ADDENDUM NO. 2

June 27, 2022

Additions and Renovations to Edgewood Intermediate School
7620 E Edgewood Ave.
Indianapolis, IN, 46239

Addendum Two (AD.02) to the drawings and specifications prepared by Gibraltar Design and The Skillman Corporation for **Edgewood Intermediate School Additions and Renovations** for Franklin Township Community School Corporation, Indianapolis, Indiana.

© GIBRALTAR DESIGN SHEET
L SF113

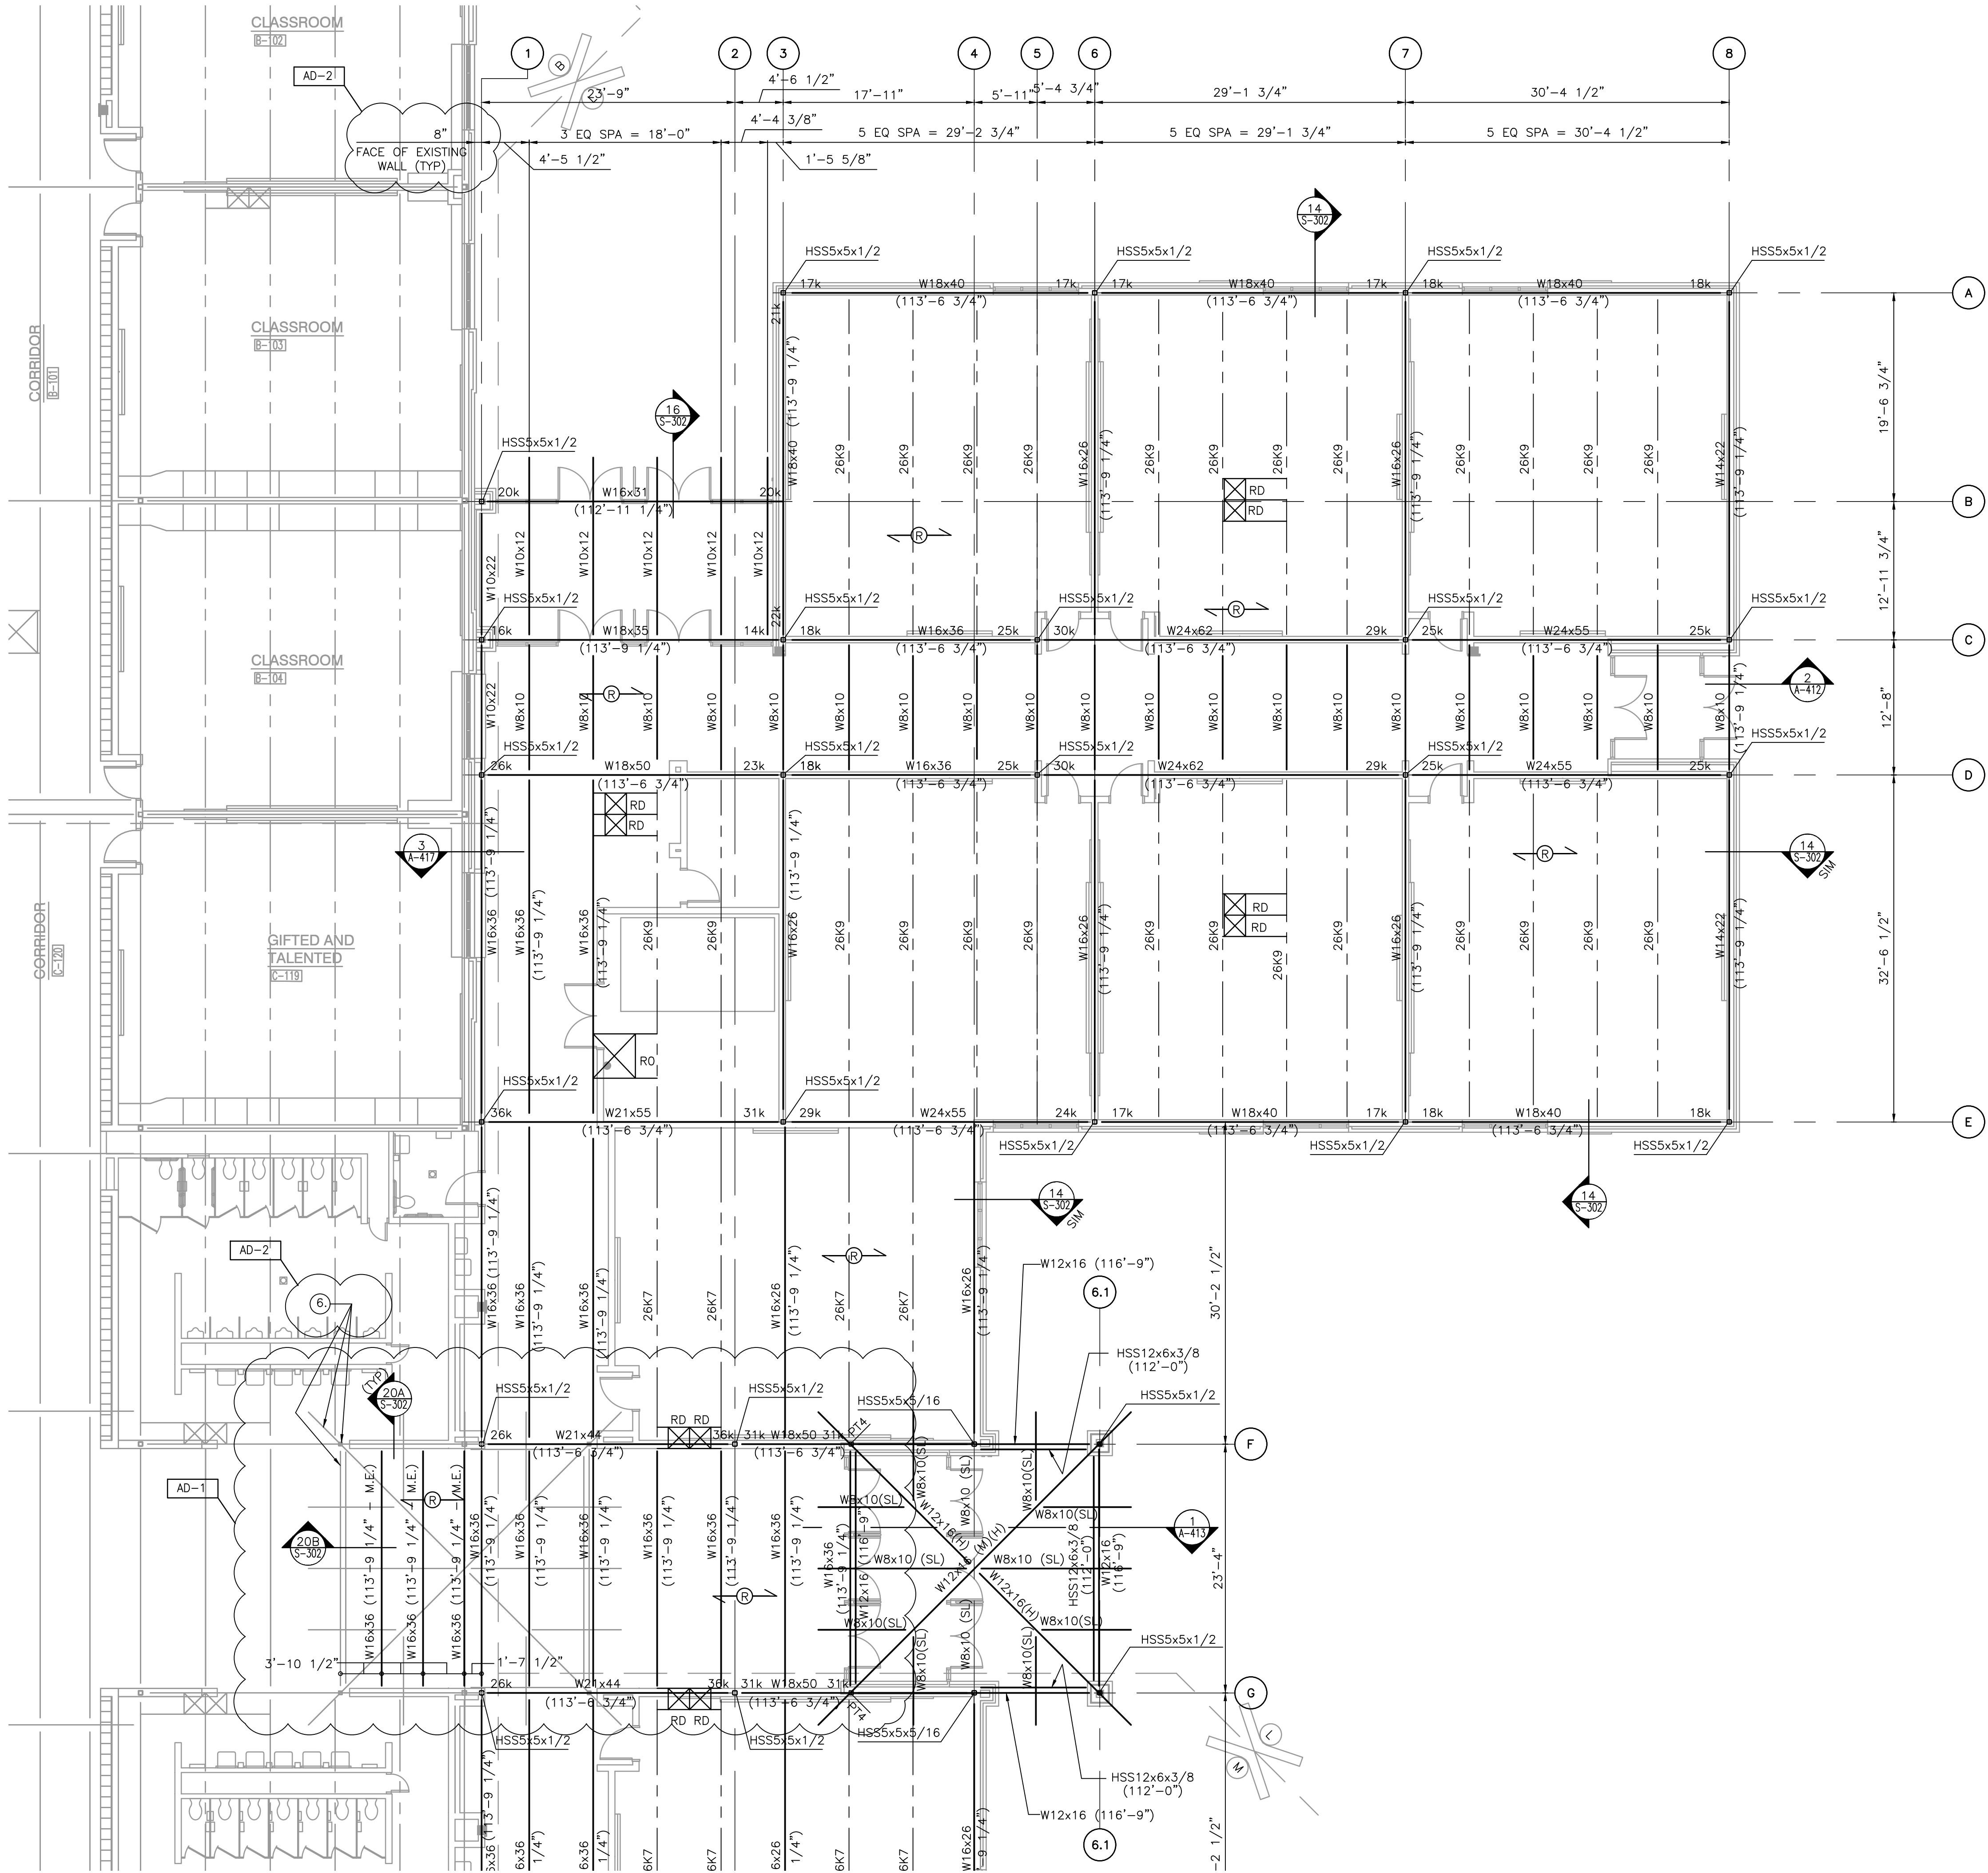
- A. Refer to revised, full-size drawing, included in this Addendum, for the following revisions:
 - 1. Add dimension line to show new framing grids start distances away from existing building line near Grid 1.
 - 2. Add Note 6 to review the demo required of existing canopy.
